MEMORANDUM: Robert E. Browning, Director
Division of Waste Management

FROM: F. Robert Cook, Senior On-Site Licensing
Representative, Basalt Waste Isolation
Project (BWIP)

SUBJECT: OBSERVATIONS, COMMENTS AND RECOMMENDATIONS
FOR THE PERIOD MARCH 29 TO MAY 2, 1986

COMPARISON OF TYPICAL WASTE PACKAGES

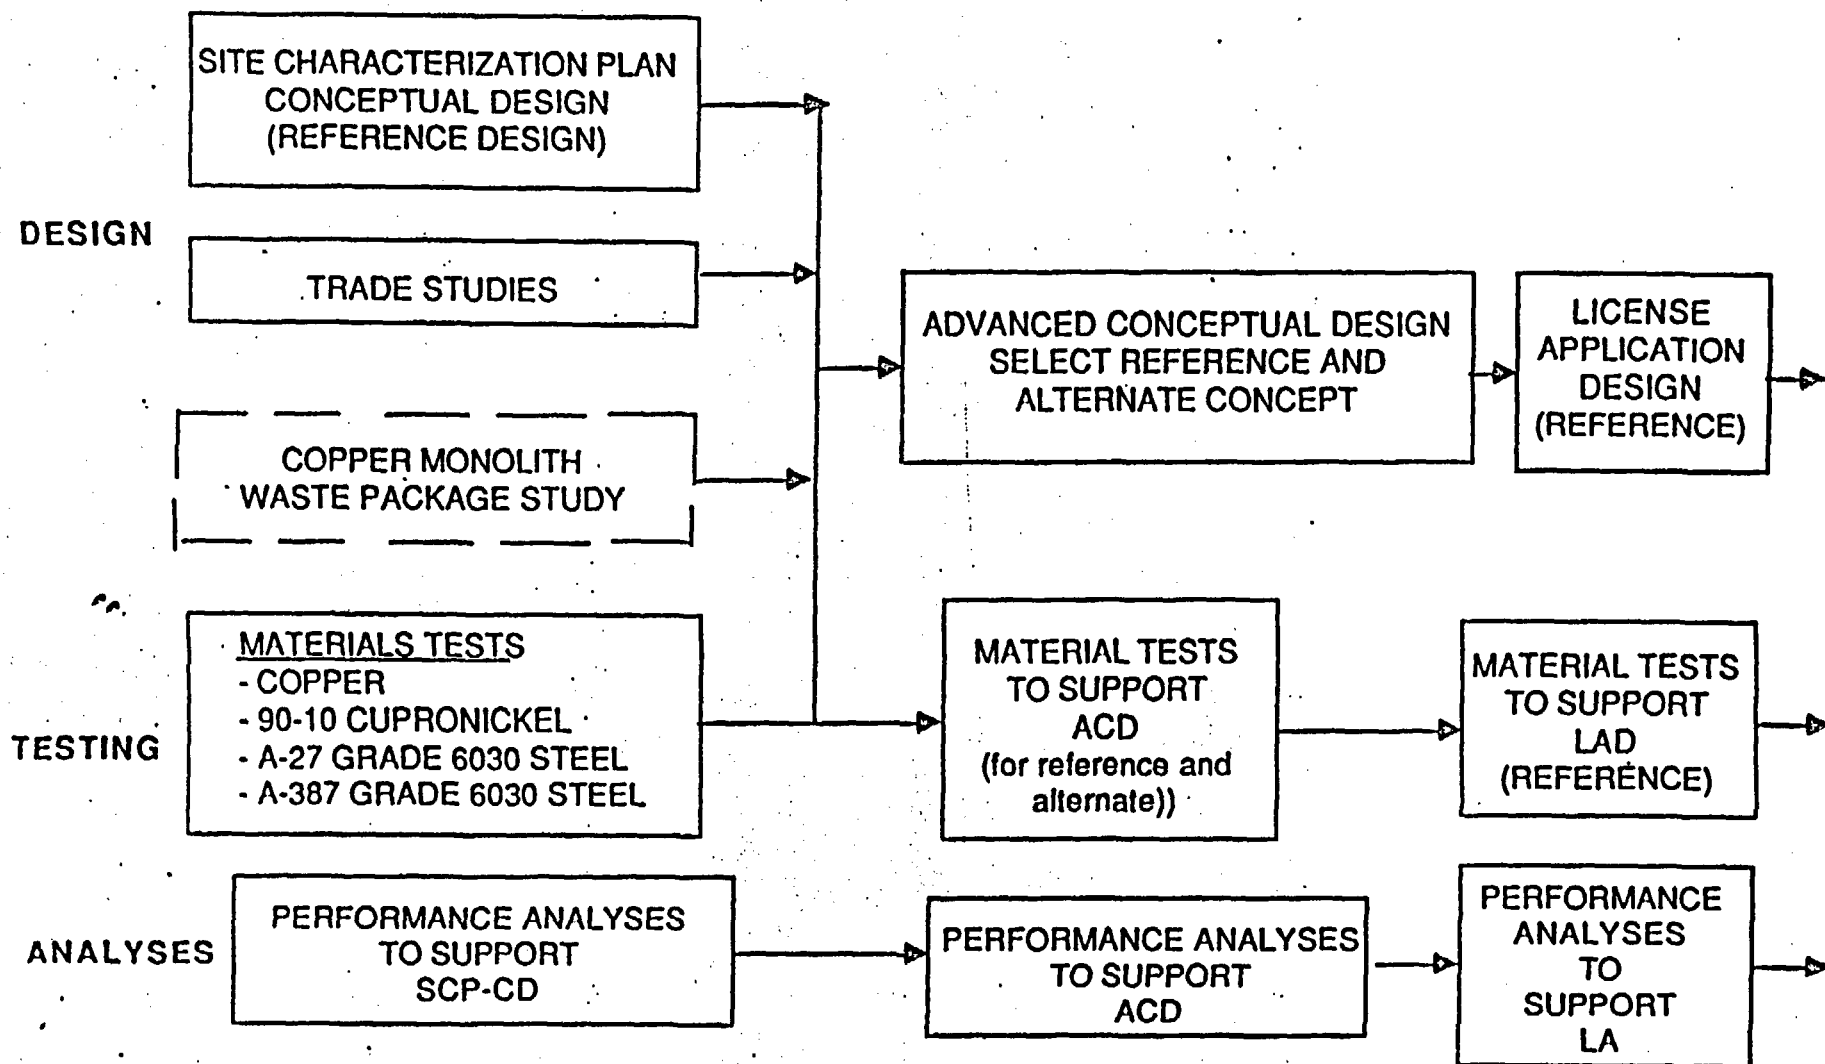
The latest basic characteristics specified for the waste package designs for a basalt repository are contained in Attachment A to this memorandum. This Attachment does not contain the characteristics for the SRP waste package, however, the characteristics listed for the West Valley waste package would likely be similar to those to be specified for the SRP waste. The information in the Attachment was recently presented to a German delegation visiting Hanford.

4 Not calculated in the Computational Brief. The 0.8 cm (0.3") diametrical clearances between the OD of the shell and ID of the borchole used elsewhere may not be adaaquate when practical tolerances are considered.

PROBABILITY CURVES FOR FAILURE OF A TYPICAL CONTAINER

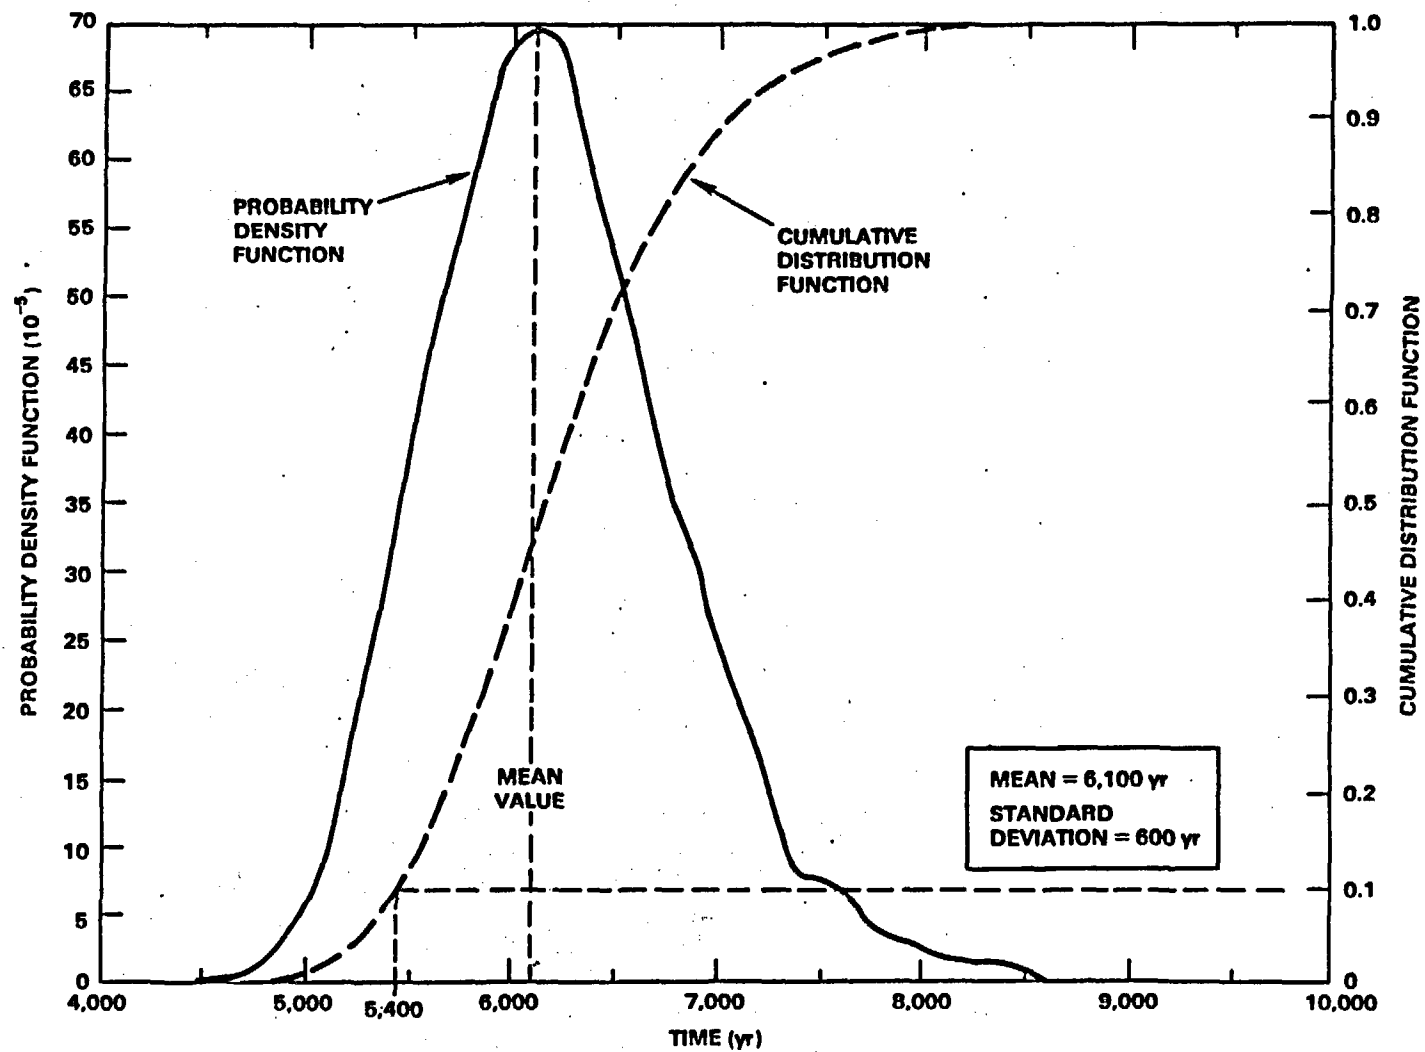
c. Attachment B identifies performance objectives which appear to translate the words, "substantially complete" from the waste package objectives in 10CFR60.113(a)(1)(ii)(A) to 90% reliability relative to meeting the 1000 year containment. BWIP has also identified the 90% reliability design objective for the 10,000 year release rate performance objective in 10CFR60.113(a)(1)(ii)(B). Neither of the reliability statements has an accompanying confidence statement which designers need as an appropriately specified design target in creating a conceptual design with appropriate plans for testing and analyses necessary to validate design procedures, including the key performance analyses. For example, a 90% reliability with a 50% confidence performance objective would involve a greatly reduced scope for R&D when compared to an R&D effort for a statement of 90% reliability with a 99% confidence. Without a specified target for confidence design will remain inadequately controlled.

d. I recommend that the Staff take positions relative to the performance objectives as to what are acceptable statements of reliability and confidence to support findings related to safety, for example, reasonable assurance of substantially complete containment at 1000 years. Without such guidance, DOE could continue to plan inadequately for their R&D, including site characterization. A proactive Staff position in this area may occasion DOE to consider appropriate specification of performance objectives and help surface differences, if there are any, at an early date. In any case this area of performance allocation warrants early critical Staff assessment to determine what is practical in way of long term reliability and confidence requirements for performance of engineered and natural structures, systems and components, including both barriers and auxiliary components, which are not barriers, but which are intended to act to establish and maintain conditions necessary for good barrier performance.
